Access Compliance Report

Public Rights-of-Way

(Curb Ramps)

Intersection ID: 24428	Main Street: PRESCOTT_POND_LN	Cross Street: SAINTFIELD_PL	Location: NE
ADA ID: A7D7D40E9C72	Ramp Type: PerpDiag	Initial Pass/Fail: Fail	Overall Compliance: No
Codes/Mitigation Info/Possible Solution			Severity Score: 10
Field Measurements/Component Compliance

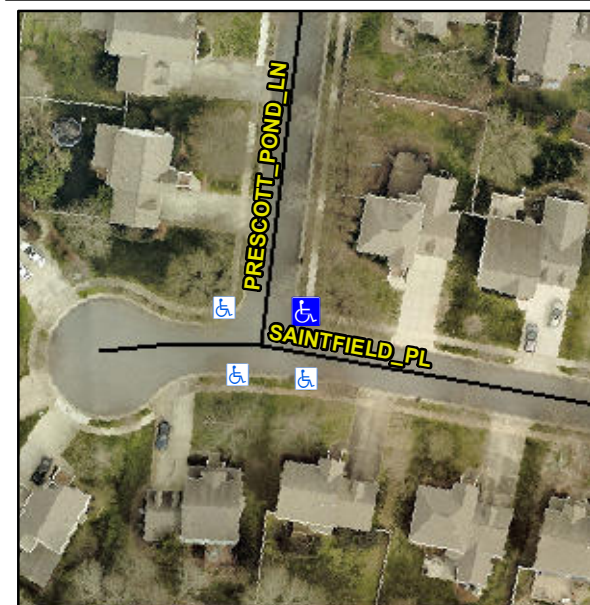
Not Found, R304.5.1, R304.5.3

Compliance	Description	Data	Compliance	Description	Data
N/A	Ramp Length (in)	48.0	Yes	Ramp Slope (%)	5.1
No	Ramp Width (in)	46.5	No	Ramp XSlope (%)	3.2
N/A	Flare Type LT	N/A	N/A	Flare Type RT	N/A
N/A	Flare Slope LT (%)	N/A	N/A	Flare Slope RT (%)	N/A
N/A	Flare Traversable LT?	N/A	N/A	Flare Traversable RT?	N/A
N/A	Landing Length (in)	N/A	N/A	DWS Provided?	N/A
N/A	Landing Width (in)	N/A	N/A	DWS Contrast?	N/A
N/A	Landing Slope (%)	N/A	N/A	DWS Length (in)	N/A
N/A	Landing X Slope (%)	N/A	N/A	DWS Full Width?	N/A
N/A	Landing Curb? (Y/N)	N/A	N/A	DWS Offset (in)	N/A
N/A	Shared Landing?	N/A			
N/A	Gutter Ponding?	N/A	N/A	Gutter Slope (%)	N/A
N/A	Gutter Lip Ht (in)	N/A	N/A	Gutter X Slope (%)	N/A
N/A	Painted X Walk1?	No	N/A	Painted X Walk2?	No
	X Walk 1 Direction	To SW		X Walk 2 Direction	To S
N/A	X Walk 1 Width (in)	N/A	N/A	X Walk 2 Width (in)	N/A
	X Walk 1 Slope (%)	1.1		X Walk 2 Slope (%)	3.7
	X Walk 1 X Slope (%)	1.4		X Walk 2 X Slope (%)	0.0

N/A	Ramp inside XWalk1?	N/A	N/A	Ramp inside XWalk2?	N/A
	Road Slope (%)	2.0	N/A	Clear Space?	N/A
	Road X Slope (%)	5.2	N/A	Clear Space to XWalk (in)	N/A
N/A	Any Obstructions?	N/A	N/A	Storm Grate/Utility Hazard?	N/A
	Obstruction Type			Storm Grate/Utility Type	
		N/A			N/A
			Yes	Surface Condition? (G/P)	Good

Remove & Replace Curb Ramp With Two New Directional Ramps or Equivalent.
